DART SERVICE INSTRUCTION

TO AMEND INSTALLATION INSTRUCTIONS D206-642 REV. L AND
INSTRUCTIONS FOR CONTINUED AIRWORTHINESS ICA-D206-642 REV. 1

REF. FAA STC: SA00475SE

4.4 206L/L-1/L-3/L-4 High Gear Skid tubes (D206-642)
32.13 206L/L-1/L-3/L-4 High Gear Skid tubes (ICA-D206-642)

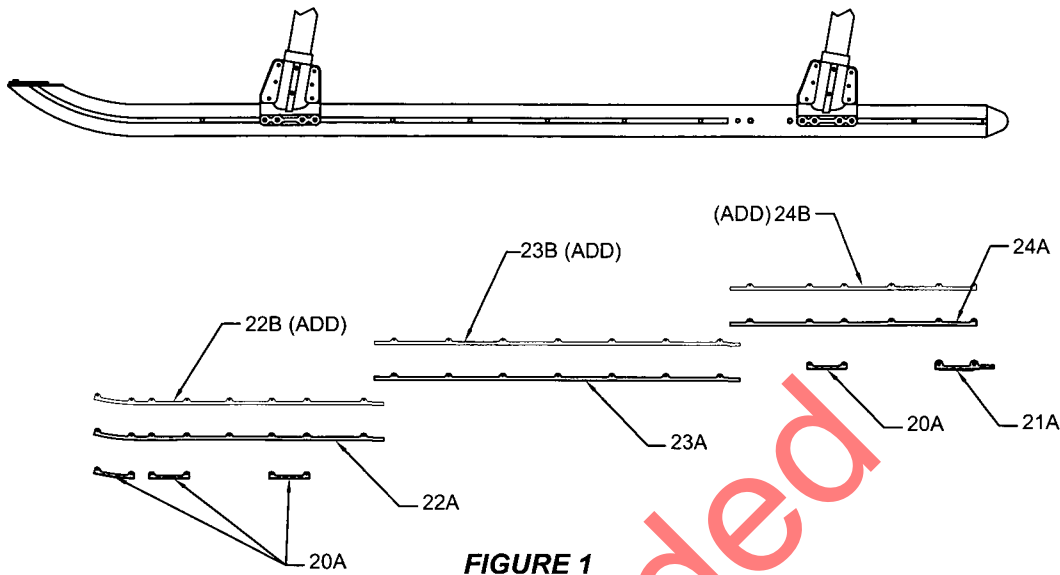
- a) REPLACE THE CARBON STEEL WEAR PADS AND WEARSHOES WITH STAINLESS STEEL WEARPADS AND WEARSHOES PER THE UPDATED PARTS LIST ON SHEET 3.
- b) ADD NEOPRENE GASKETS BETWEEN THE SKIDTUBE AND WEARSHOES PER THE UPDATED PARTS LIST ON SHEET 3 AND PER FIGURE 2 ON SHEET 4.
- c) REPLACE THE CARBON STEEL FASTENERS FOR THE WEARPADS AND WEARSHOES WITH STAINLESS STEEL FASTENERS PER THE UPDATED PARTS LIST ON SHEET 3.
- d) AMEND THE PARTS LIST IN SECTIONS 4.3 AND 4.4 OF INSTALLATION INSTRUCTIONS D206-642 REV. L OR EARLIER AND SECTIONS 32.12 AND 32.13 OF THE INSTRUCTIONS FOR CONTINUED AIRWORTHINESS ICA-D206-642 REV. 1 OR EARLIER AS SHOWN ON SHEET 3.

20A			6			D3537-1	WEARPAD (REPLACES D2648-3)	(MODIFY)
21A			1			D3537-3	WEARPAD (REPLACES D3429-1)	(MODIFY)
22A			1	1		D3535-15	WEARSHOE (REPLACES D2656-15)	(MODIFY)
22B			1	1		D3536-15	GASKET	(ADD)
23A			1	1		D3535-23	WEARSHOE (REPLACES D2656-23)	(MODIFY)
23B			1	1		D3536-23	GASKET	(ADD)
24A			1	1		D3535-37	WEARSHOE (REPLACES D2656-37)	(MODIFY)
24B			1	1		D3536-37	GASKET	(ADD)
26A			60			MS27039-1C08	SCREW	(MODIFY)
26B			60			AN960C10L	WASHER	(MODIFY)

206 A/B SKIDTUBES
(D206-642-111/-112/-211/-212/-213/-214)

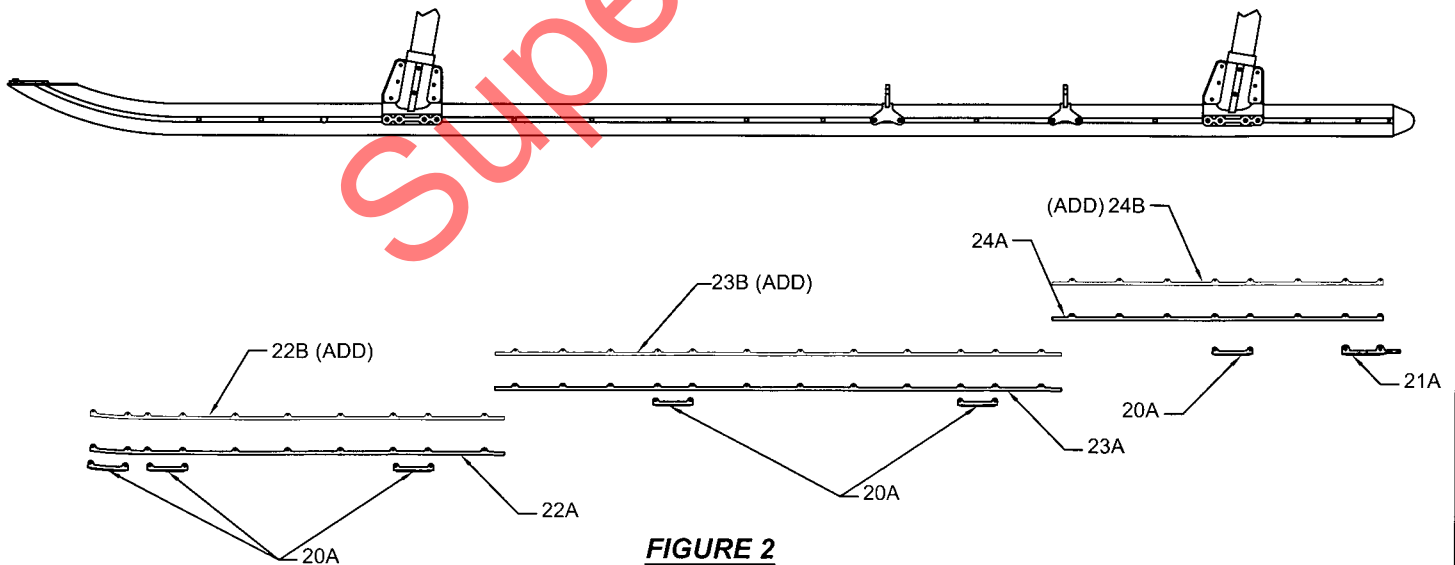
- a) REPLACE THE CARBON STEEL WEAR PADS AND WEARSHOES WITH STAINLESS STEEL WEARPADS AND WEARSHOES PER THE UPDATED PARTS LIST ON SHEET 2.
- b) ADD NEOPRENE GASKETS BETWEEN THE SKIDTUBE AND WEARSHOES PER THE UPDATED PARTS LIST ON SHEET 2 AND PER FIGURE 1 ON SHEET 4.
- c) REPLACE THE CARBON STEEL FASTENERS FOR THE WEARPADS AND WEARSHOES WITH STAINLESS STEEL FASTENERS PER THE UPDATED PARTS LIST ON SHEET 2.
- b) AMEND THE PARTS LIST IN SECTIONS 4.1 AND 4.2 OF INSTALLATION INSTRUCTIONS D206-642 REV. L OR EARLIER AND SECTIONS 32.10 AND 32.11 OF THE INSTRUCTIONS FOR CONTINUED AIRWORTHINESS ICA-D206-642 REV. 1 OR EARLIER AS SHOWN ON SHEET 2.
